# SERVICE BULLETIN

M-1223

## 2002-2008 TOURING MODELS STEERING HEAD BEARING TENSION CHANGE

Figure 1. Check Steering Head Bearing Swing-By

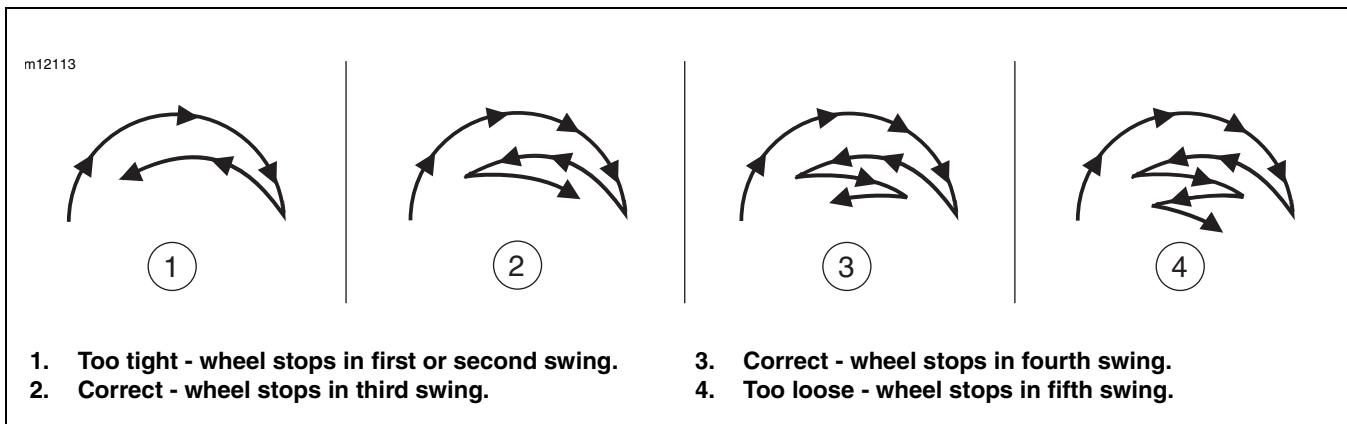
The purpose of this bulletin is to inform dealer technicians of a change in the front fork "swing-by" specification on Touring models.

Beginning in model year 2008 production, the allowable amount of swings while checking steering head bearing preload was increased to three to four swings. This change was included in the 2008 Touring service manual, and is applicable back through the 2002 model year.

See Figure 1. Perform the required procedure when needed, according to instructions in the 2008 and later Touring models service manual and verify swing-by falls into specified levels, as shown.
